ORIGINATION FORM

Proposed Revisions to a Standard Plans Index
(Please provide all information — Incomplete forms will be returned)

Index Number: 700-120

Index Title: Enhanced Highway Signing Assemblies

ENHANCED HIGHWAY SIGNING ASSEMBLIES

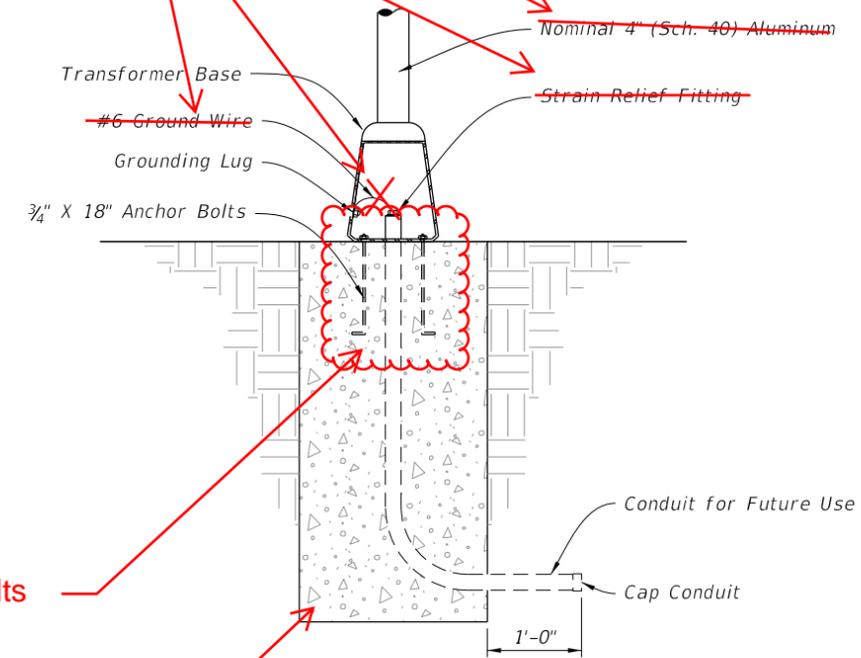
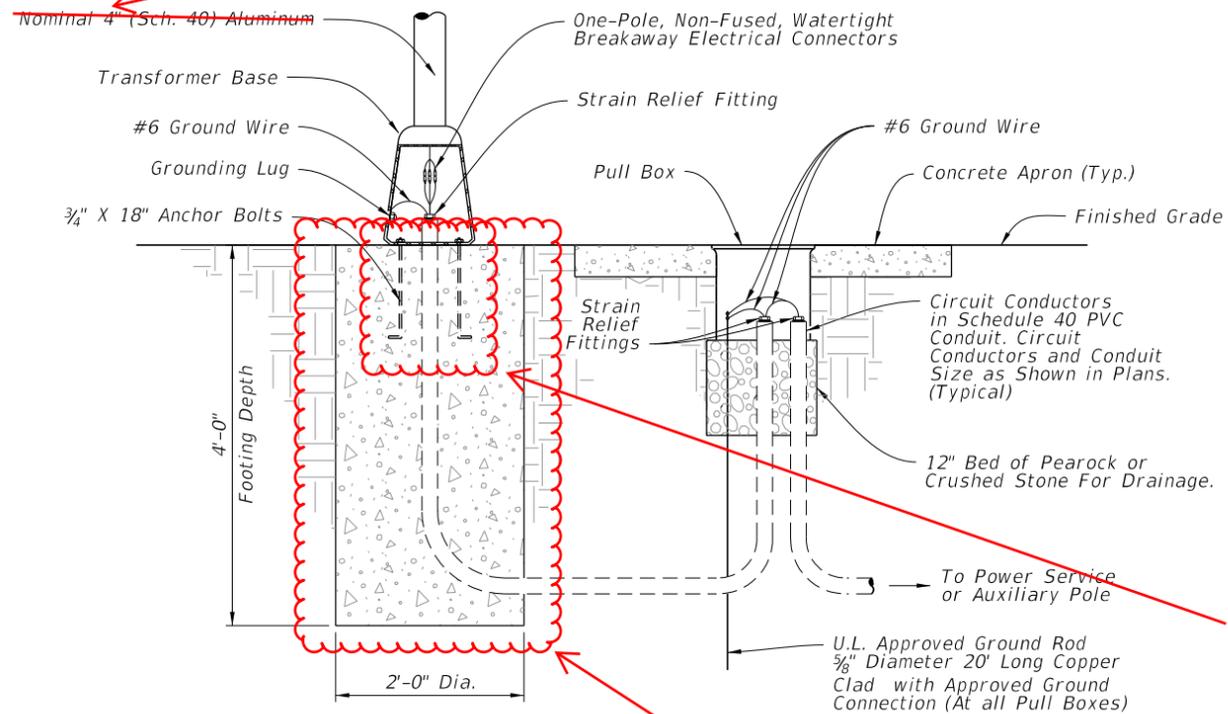
- Sheet 1: Updated General Note 4; Change all references "4" Nominal Aluminum Pole" to "Nominal 4" Aluminum Pole (Sch. 40) (4.5" OD)"; Updated anchor bolts.
- Sheet 2: Add new detail to show foundation reinforcement; Change all references "4" Nominal Aluminum Pole" to "Nominal 4" Aluminum Pole (Sch. 40) (4.5" OD)"; Updated anchor bolts.
- Sheets 3 through 11: Updated callouts to point to both details; Change all references "4" Nominal Aluminum Pole" to "Nominal 4" Aluminum Pole (Sch. 40) (4.5" OD)"; Updated anchor bolts; Added Note "Foundation reinforcement not shown".

UPDATED: Anchor Bolts

CONDUIT, WIRING, AND FOUNDATION DETAILS

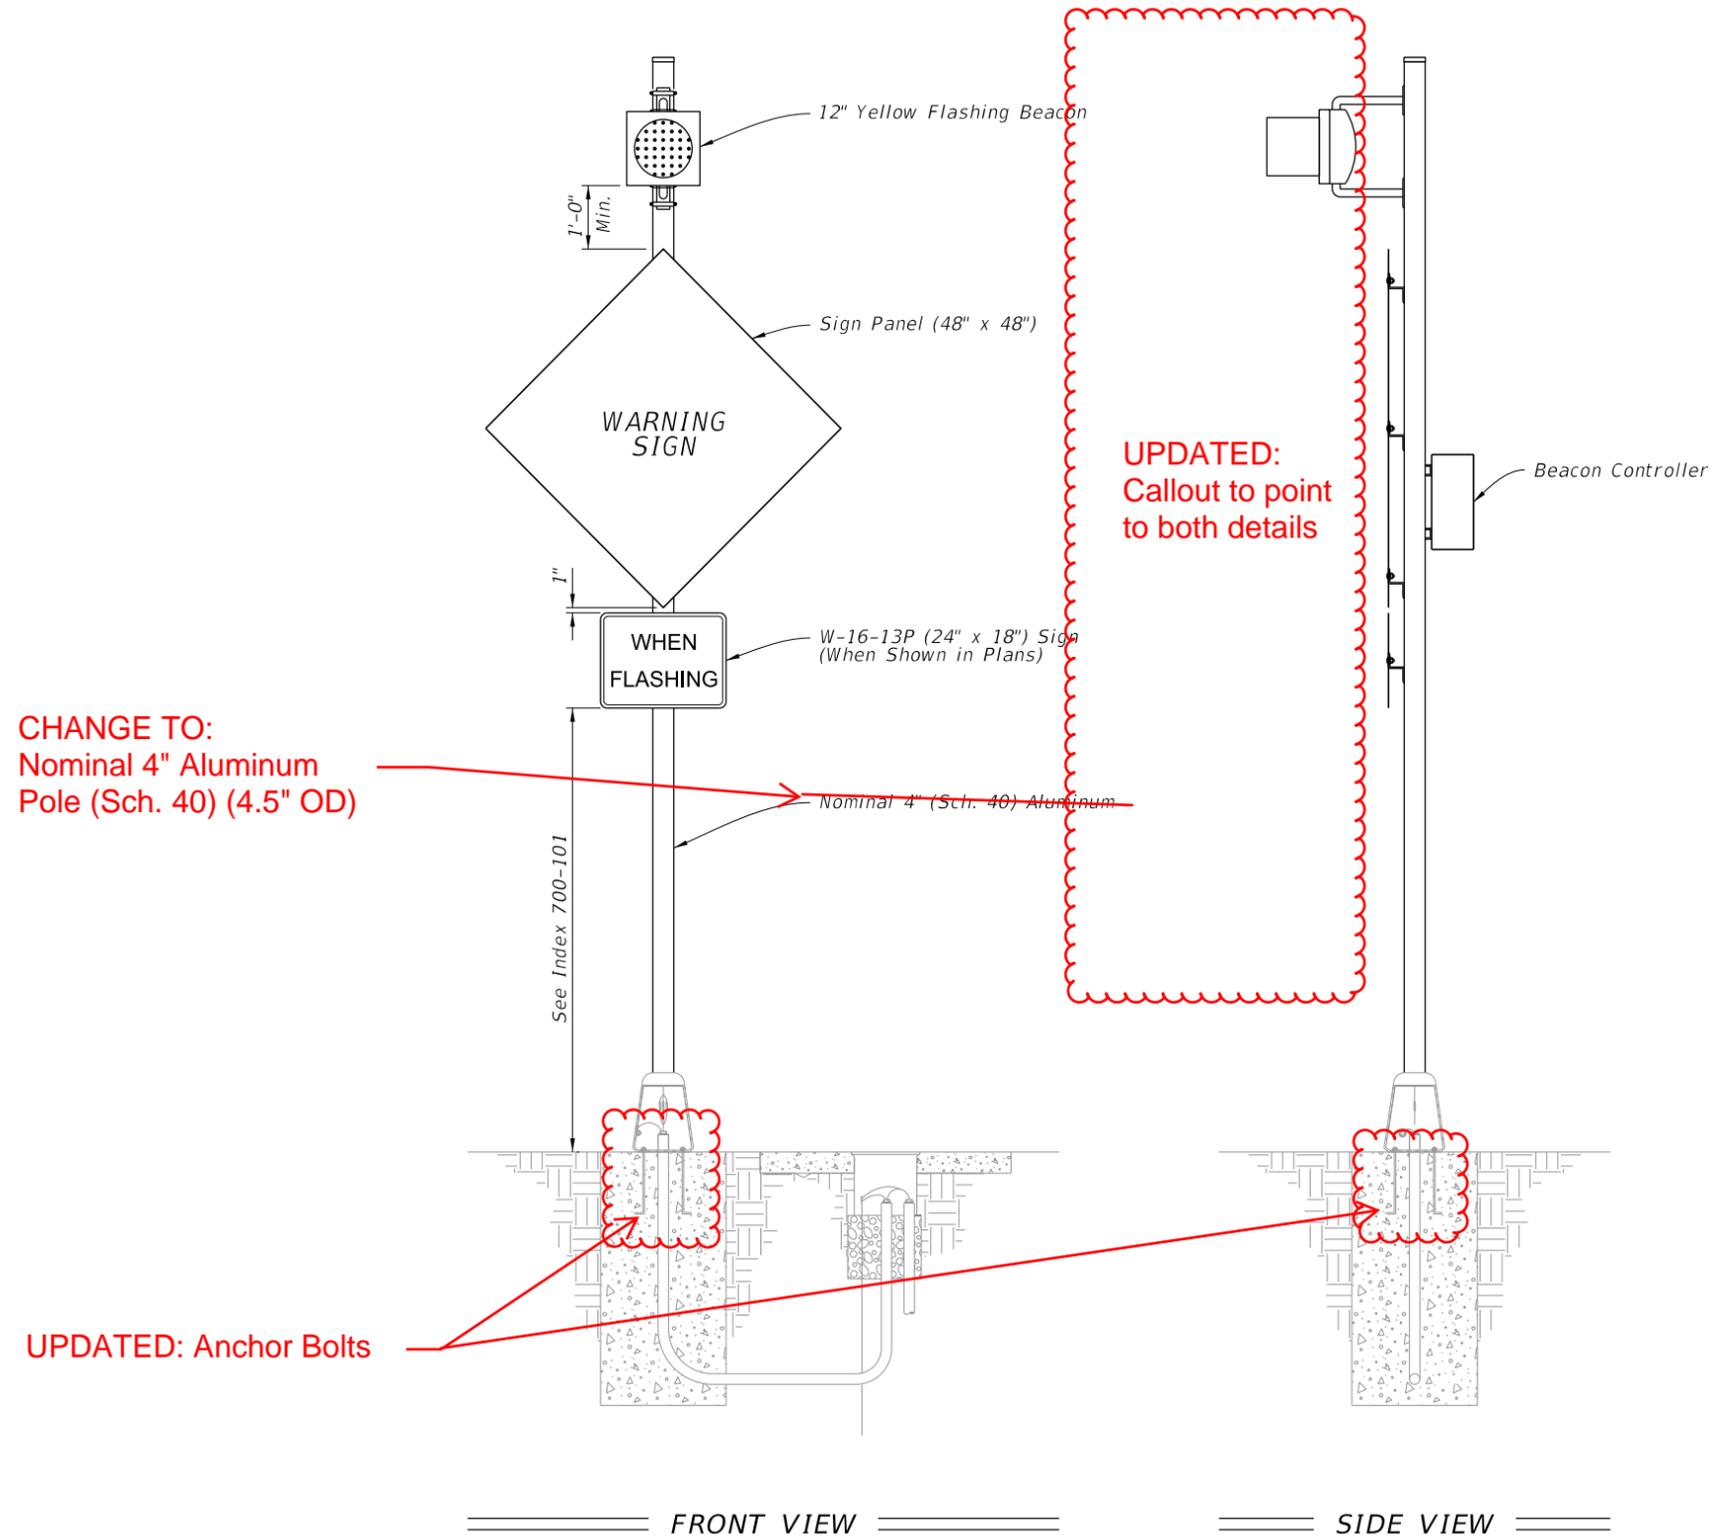
Sheet 2: Deleted the ground wire and strain relief fitting from DETAIL "B".

Sheet 2 - A ground wire is not required for a sign assembly without an auxiliary pole. The ground wire will be removed from Detail B on Sheet 2.

CHANGE TO:
Nominal 4" Aluminum
Pole (Sch. 40) (4.5" OD)

DELETED:

UPDATED: Anchor Bolts

UPDATED TO SHOW REINFORCEMENT

ROADSIDE SIGN ASSEMBLY-1

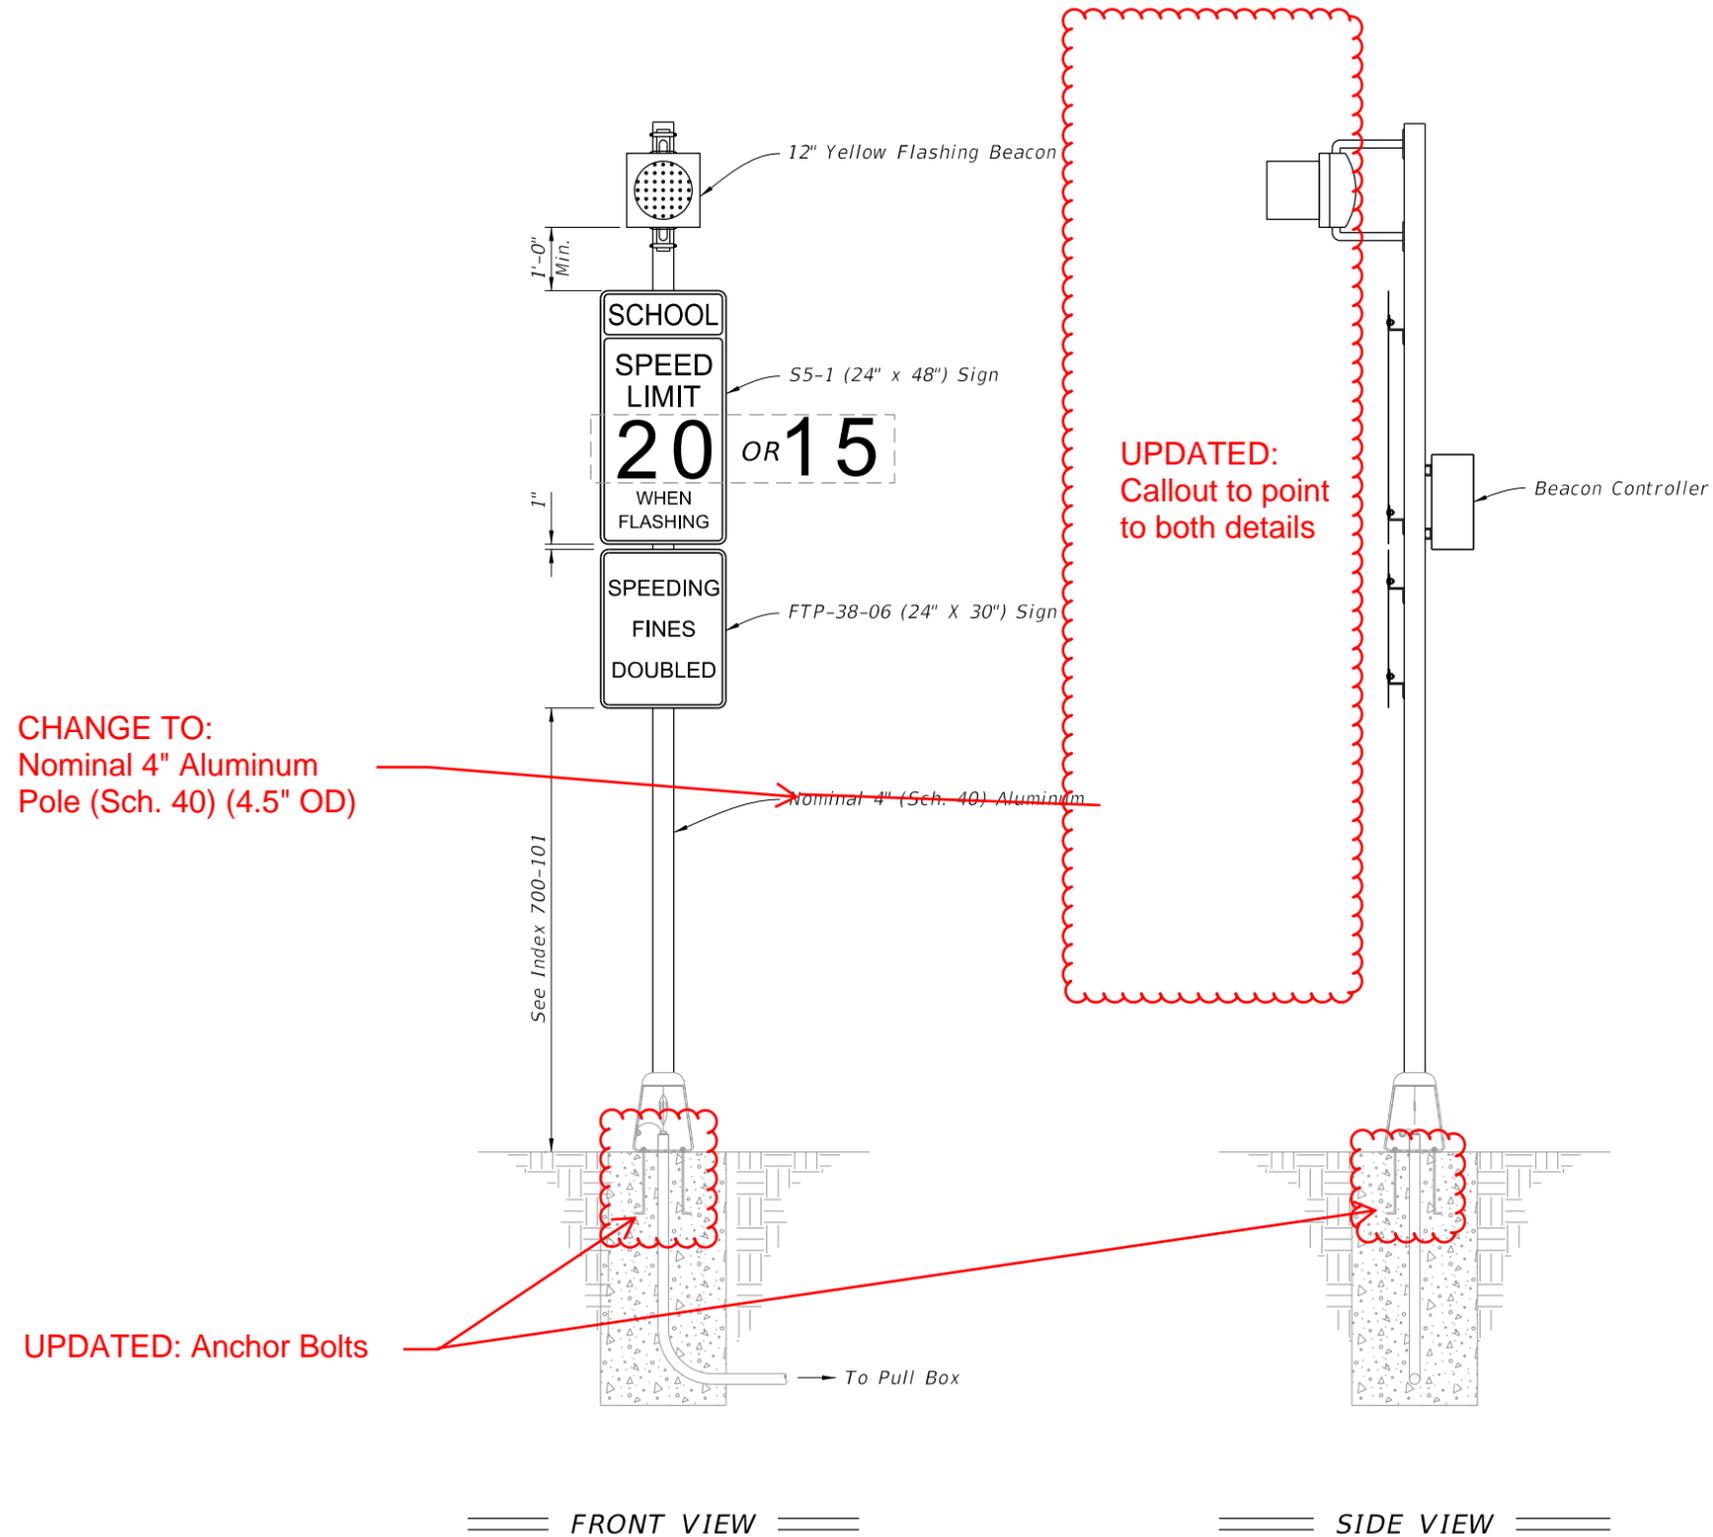
ADDED NOTE:
 Foundation reinforcement not shown.

ROADSIDE SIGN ASSEMBLY-2

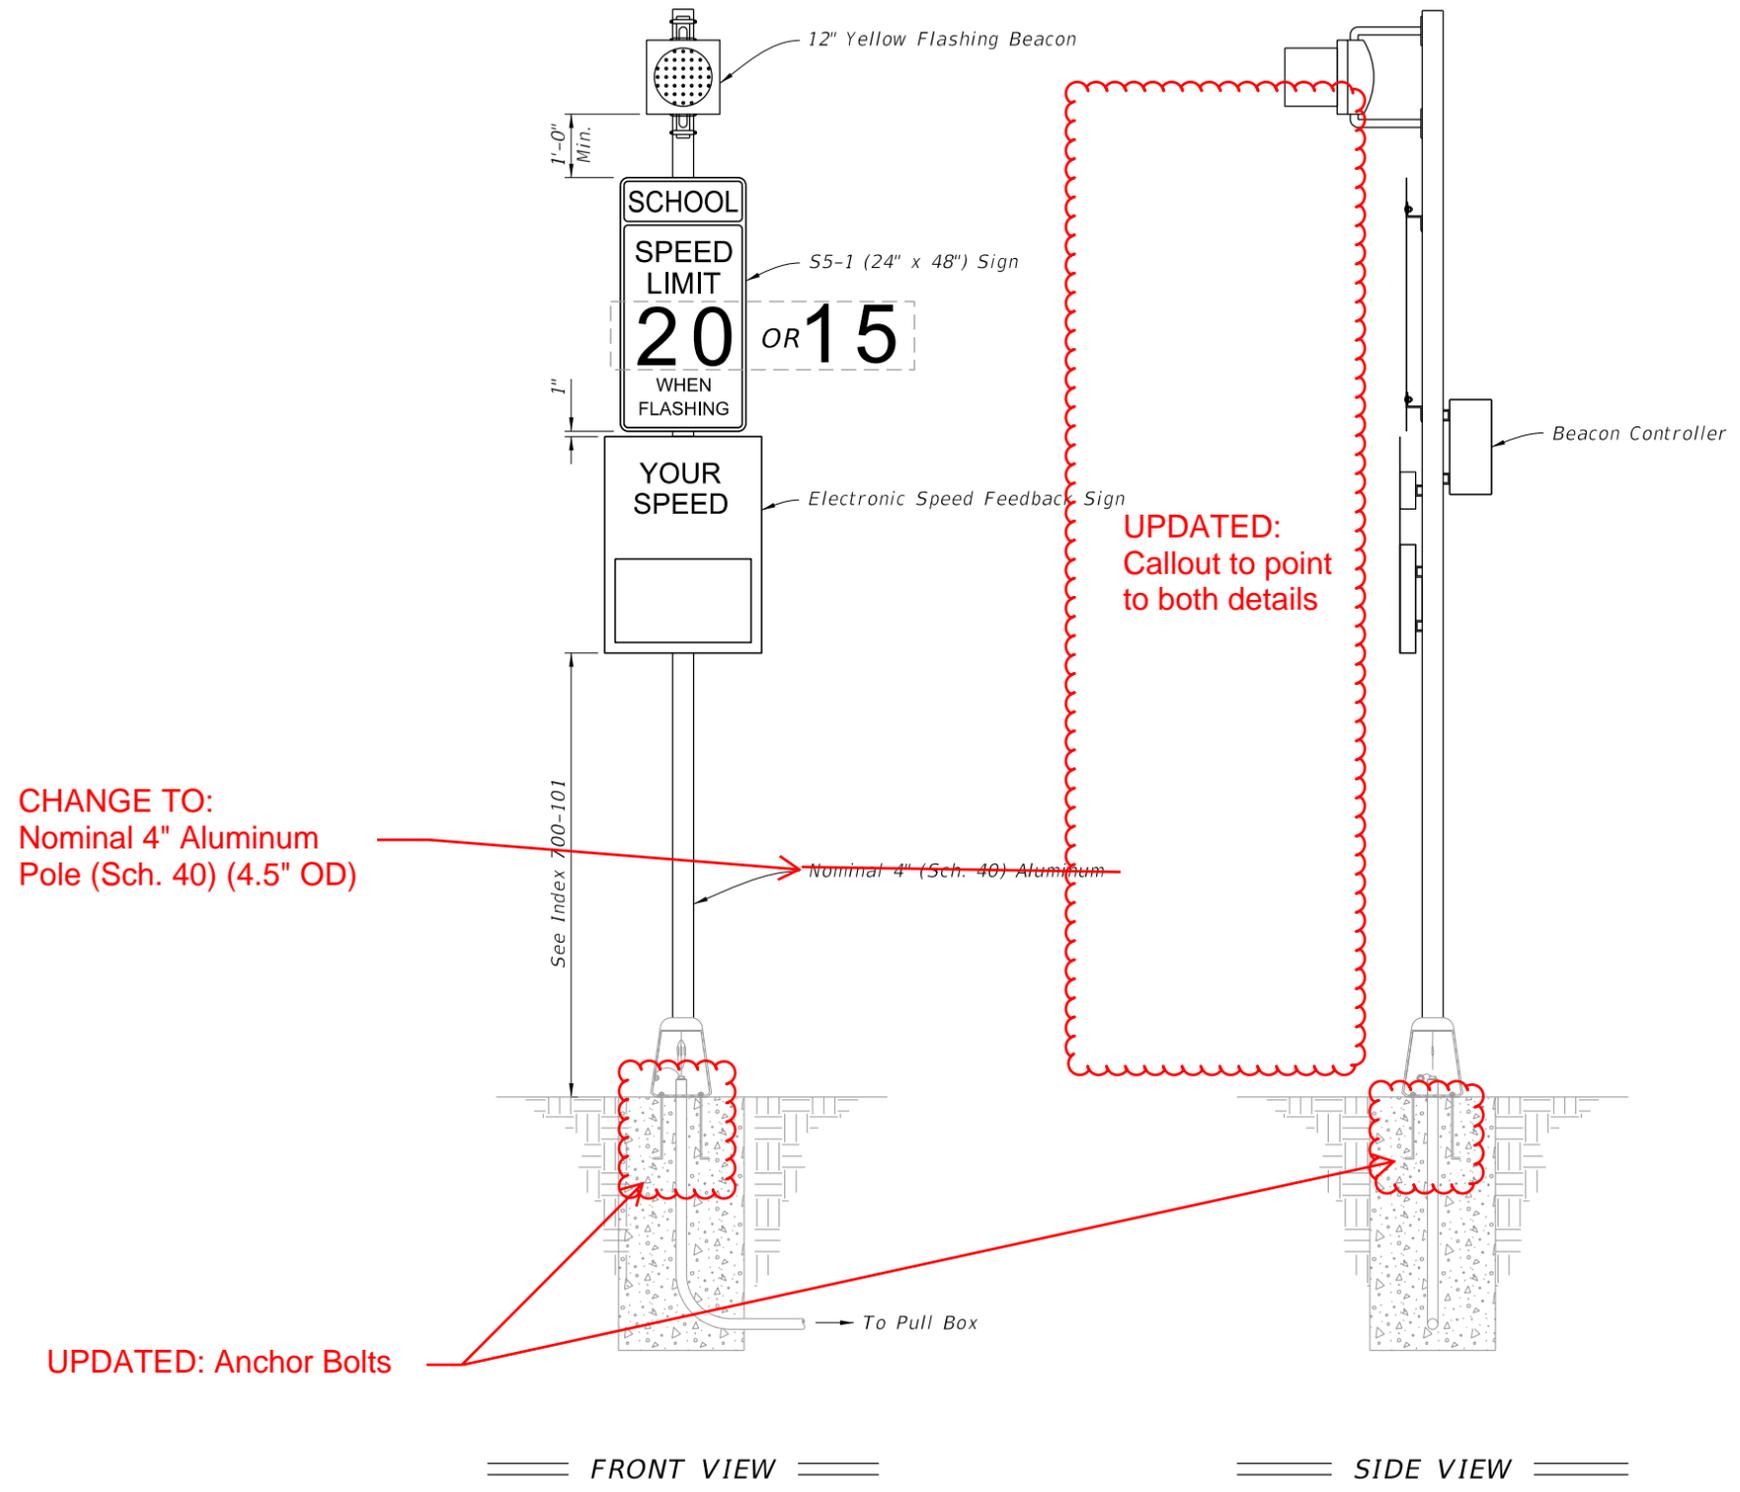
ADDED NOTE:
 Foundation reinforcement not shown.
